Bid Addendum Two

Project: **Tulip New Utilities Building**
Project No. Tulalip Tribes Project No. 2021-003

Date of Issuance: April 18, 2024

4 EAST WALL
A4.01 Scale: 1/2" = 1'-0"

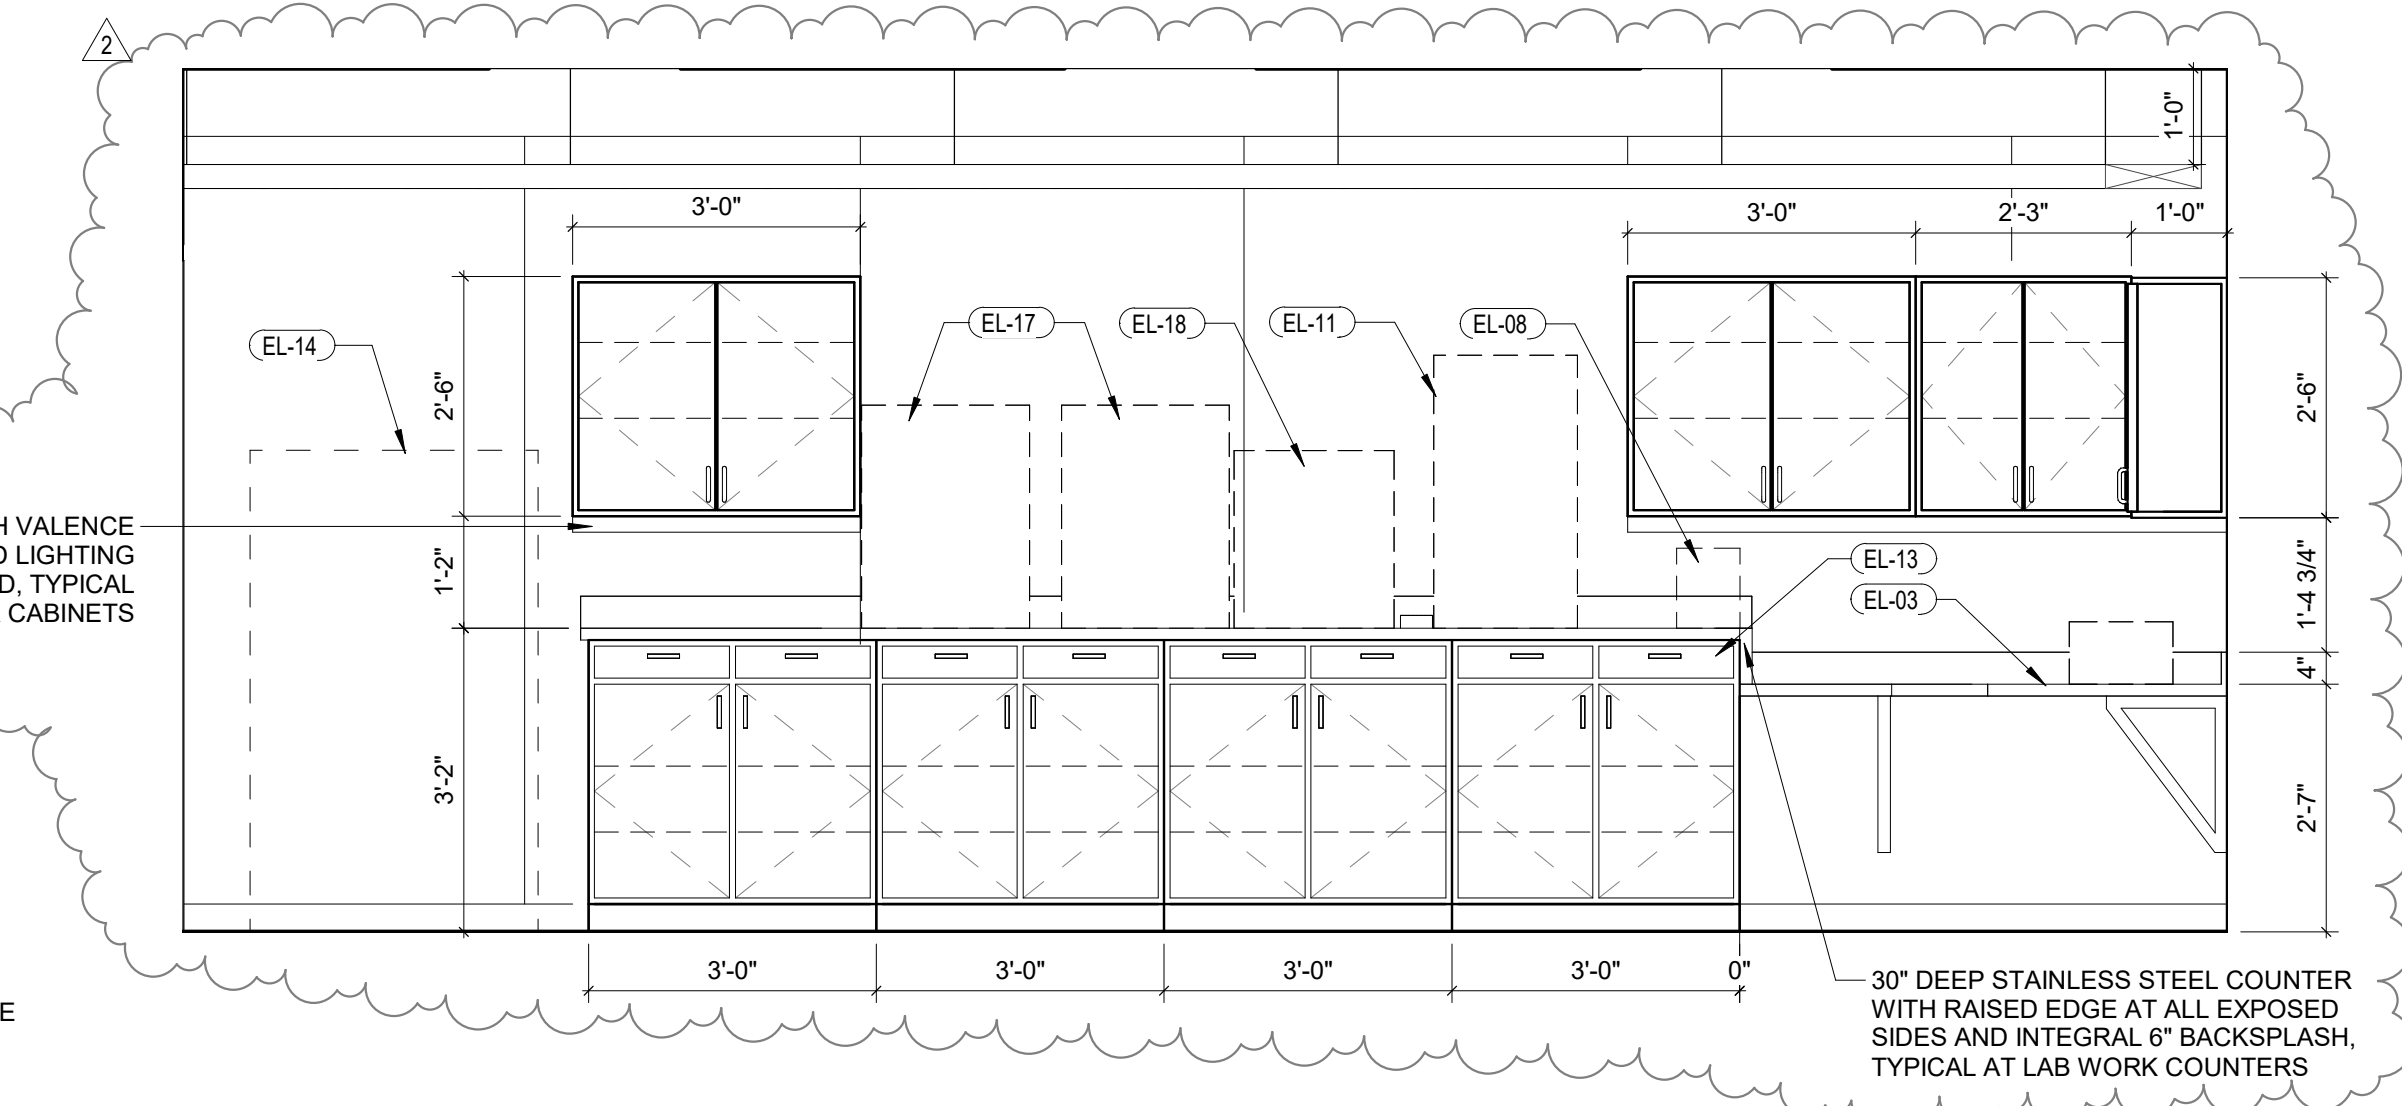
- A3.07 – revisions to lab casework (rev to 30" counter depth), Equipment Schedule (addition of towel dispenser) and dtl bugs
 - A4.01 Changes to lab casework and keynotes

1 LAB ISLAND WEST
A4.02 Scale: 1/2" = 1'-0"

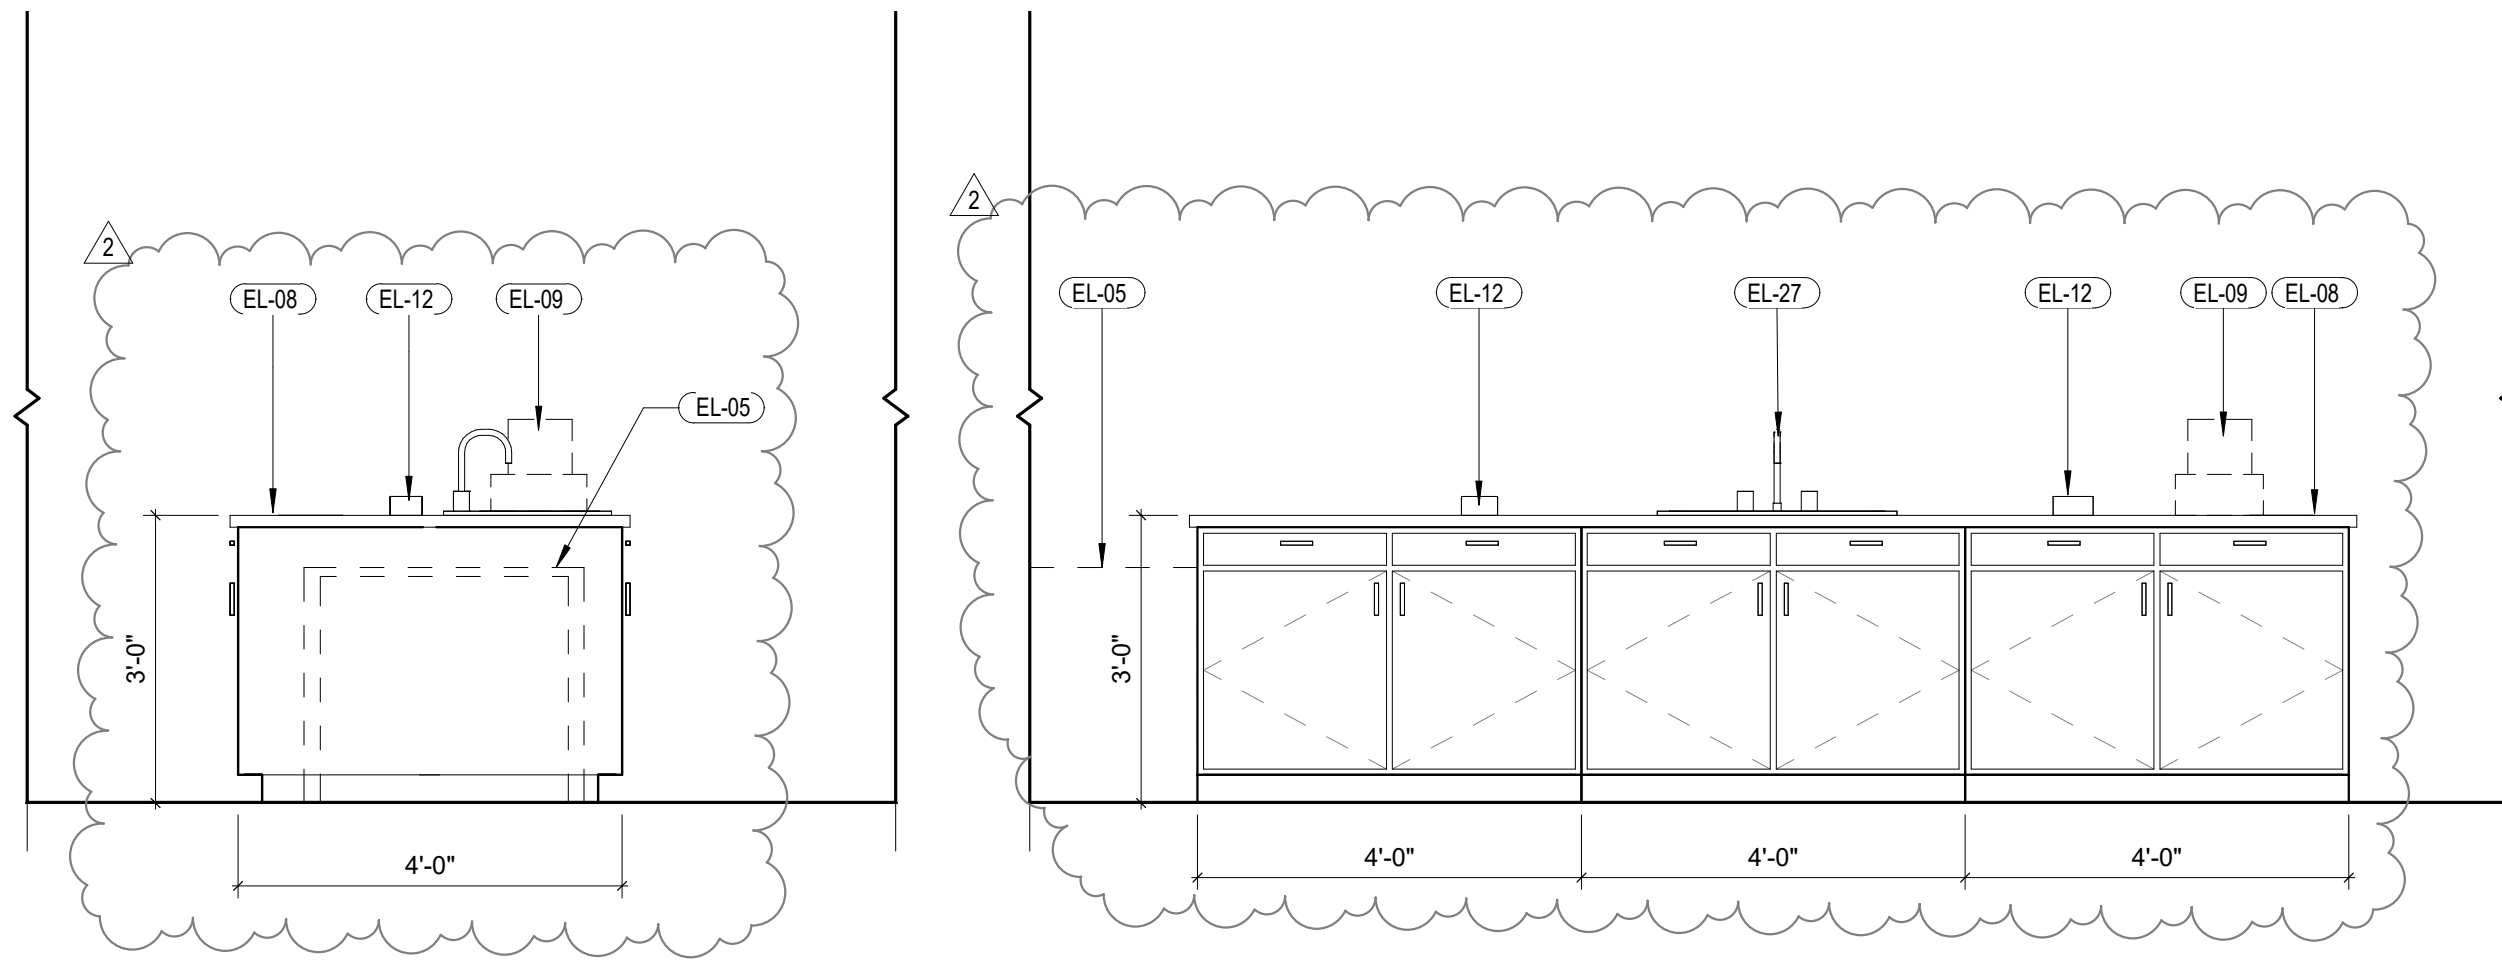
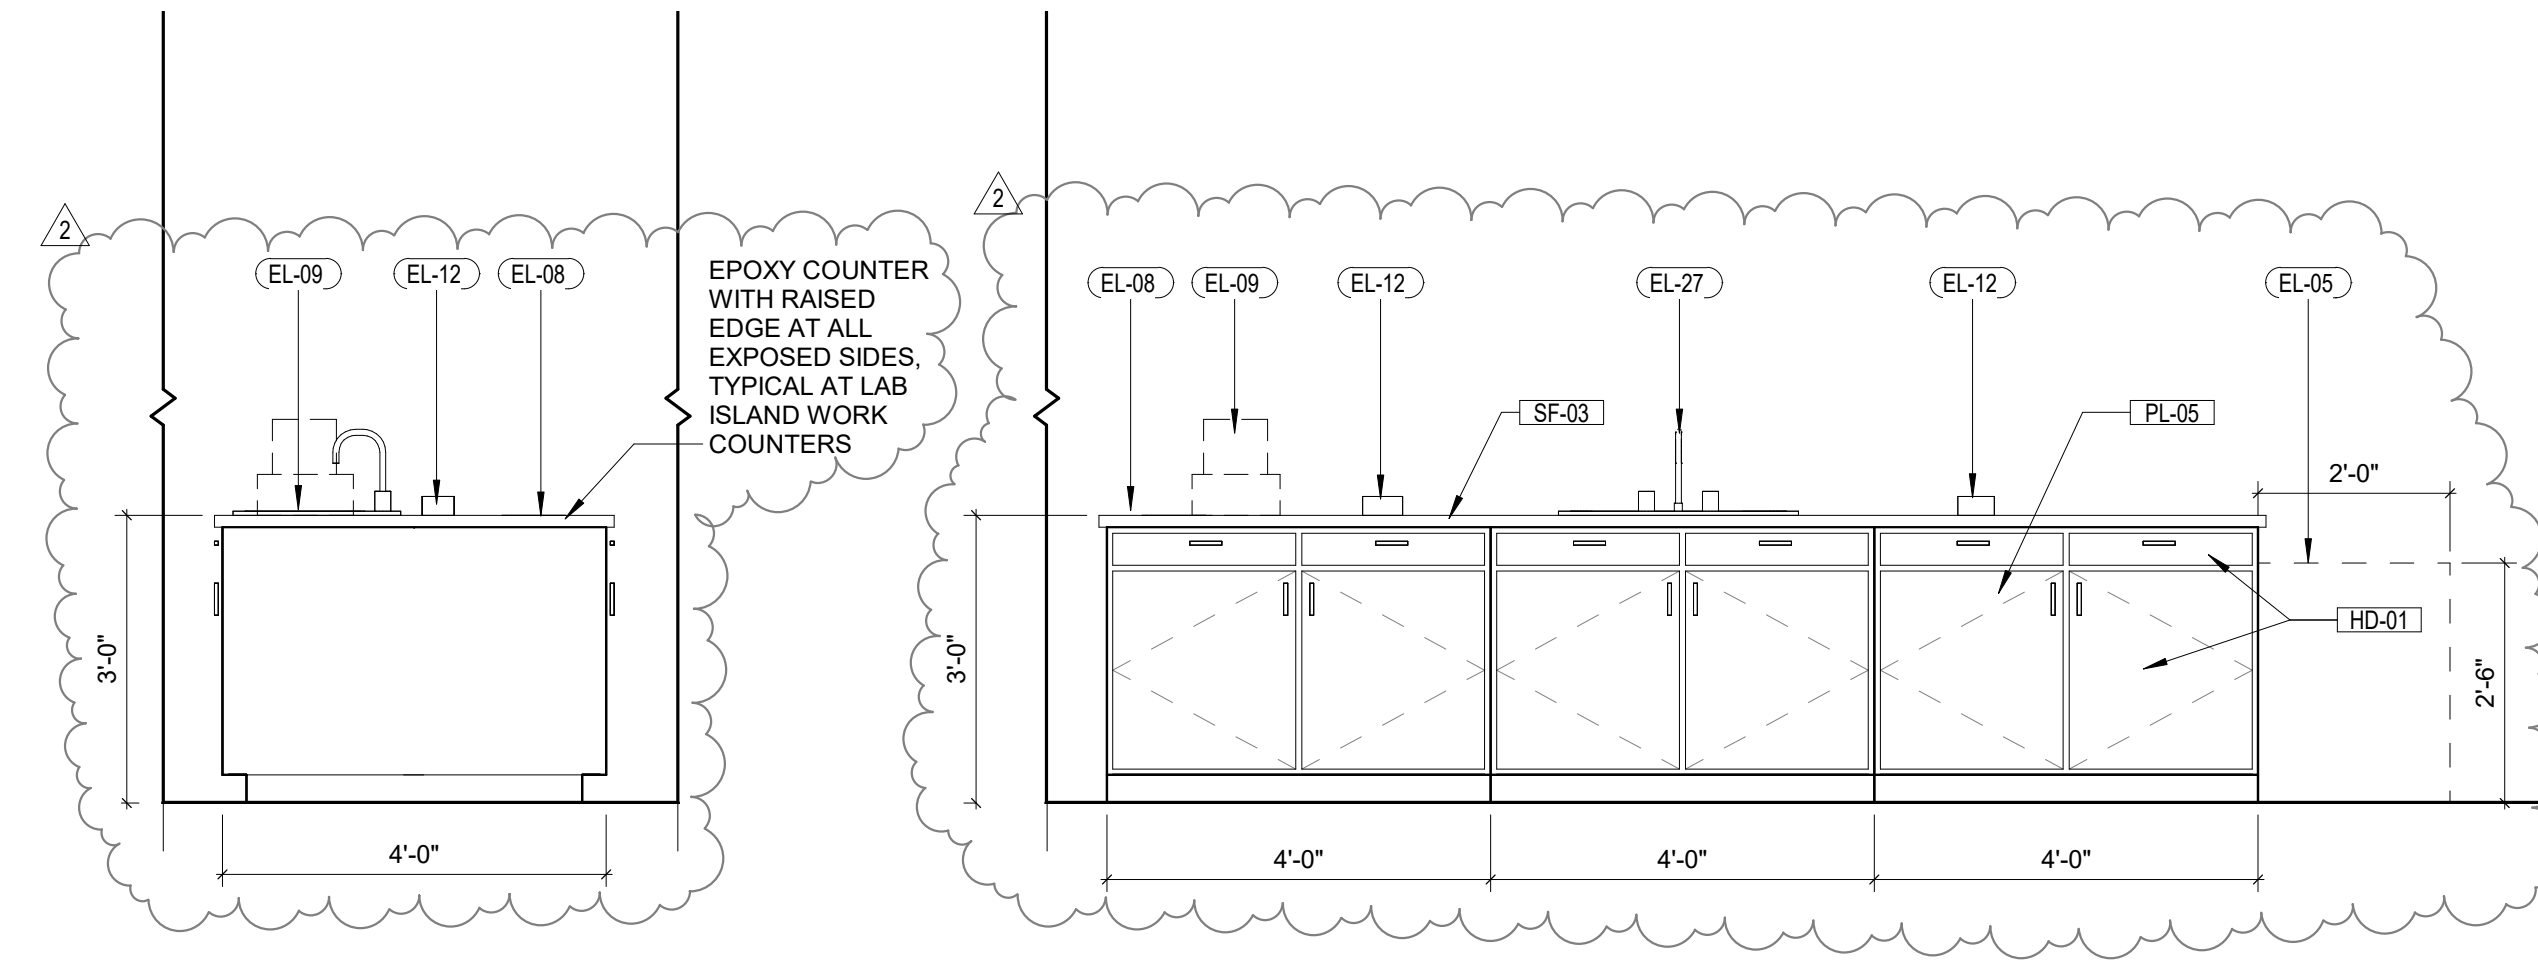
- A4.02 – addition of notes to lab casework.
 - A4.11 – change to light fixtures and clarification of washer and dryer as owner provided, owner-installed.
